文件编号 Document No.	ESP-00-2-007-03	文件名称 Document Name	产品/工艺变更通知 Product/Process Change Notice
文件版本 Document Version	1.1	保存期限 Retention Period	3 年 3 years

ESP32-D0WD 和 ESP32-S0WD 增加封测厂 Add a new Assembly and Test Manufacturing (ATM) plant for ESP32-D0WD and ESP32-S0WD							
PCN 编号 PCN No.	PCN-03-20180810	提出日期 Issue Date of PCN	2018/08/10				
产品名称 Product Name	ESP32-D0WD ESP32-S0WD	变更日期 Proposed Date of Change	2018/08/20				
封装类型/尺寸 Package Type/Size	QFN/5x5	首次出货日期 Proposed Date of First Shipment	2018/11/20				
客户批准/Customer ☒ 需要批准/Approval Required Consent: ☐ 通知, 无需批准/Notification, Approval Not Required							
变更等级/Change Classification: ☒ 主要变更/Major ☐ 轻微变更/Minor							
<u>变更原因/Reason for Change:</u> ESP32-D0WD & ESP32-S0WD 市场需求持续增长, 为满足市场需求, 持续稳定供货, 特增加封装测试厂。 In order to meet the growing market demand and ensure a stable supply of ESP32-D0WD and ESP32-S0WD, Espressif will add a new Assembly and Test Manufacturing (ATM) plant to produce the two above-mentioned products.							
<u>变更描述/Description of Change:</u> 当前状况/Current State: ESP32-D0WD & ESP32-S0WD 封测厂为 Unisem Cheng Du Co.,Ltd The current Assembly and Test Manufacturing (ATM) plant for the production of ESP32-D0WD and ESP32-S

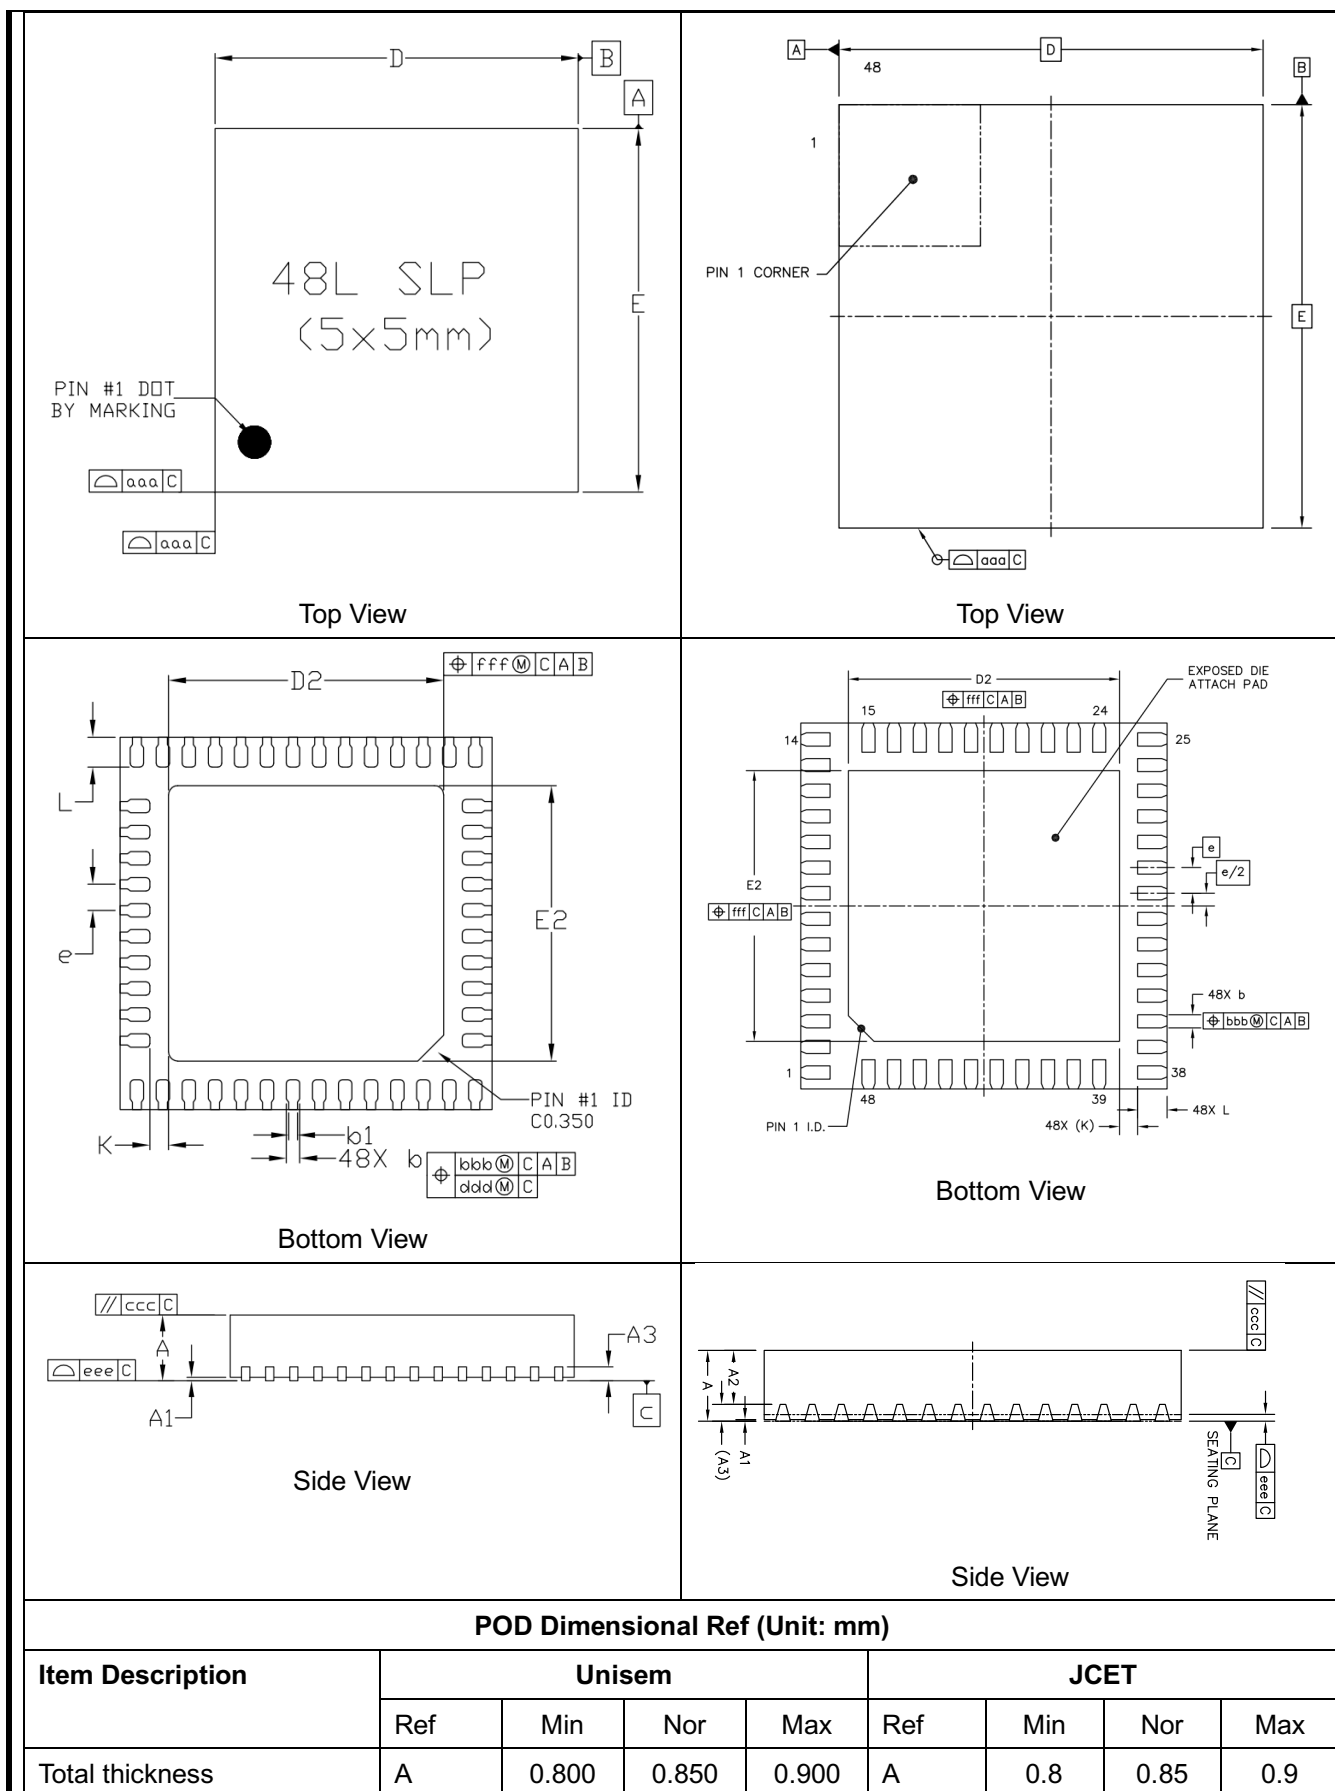
Stand off	A1	0.000	--	0.050	A1	0	0.02	0.05
Mold thickness	--	--	--	--	A2	--	0.65	--
L/F thickness	A3	0.203 REF			A3	0.203 REF		
Body size X	D	4.950	5.000	5.050	D	4.95	5	5.05
Body size Y	E	4.950	5.000	5.050	E	4.95	5	5.05
EP size X	D2	3.650	3.700	3.750	D2	3.65	3.7	3.75
EP size Y	E2	3.650	3.700	3.750	E2	3.65	3.7	3.75
Lead width	b	0.130	0.180	0.230	b	0.13	0.18	0.23
Lead end width	b1	0.070	0.120	0.170	--	--	--	--
Lead length	L	0.350	0.400	0.450	L	0.3	0.4	0.5
Lead pitch	e	0.350 BSC			e	0.35 BSC		
Lead tip to exposed pad edge	K	0.25 REF			K	0.25 REF

1. 影响产品外观，不同封装测试厂生产之芯片引脚尺寸和引脚形状不同。

The appearance of the products will not be exactly the same: the size and shape of chip pins will vary from different plants.

通过芯片背面引脚形状及尺寸可区分不同封装测试厂之产品。

The chips produced by different Assembly and Test Manufacturing (ATM) plants can be identified by the shape and size of the chip pins.
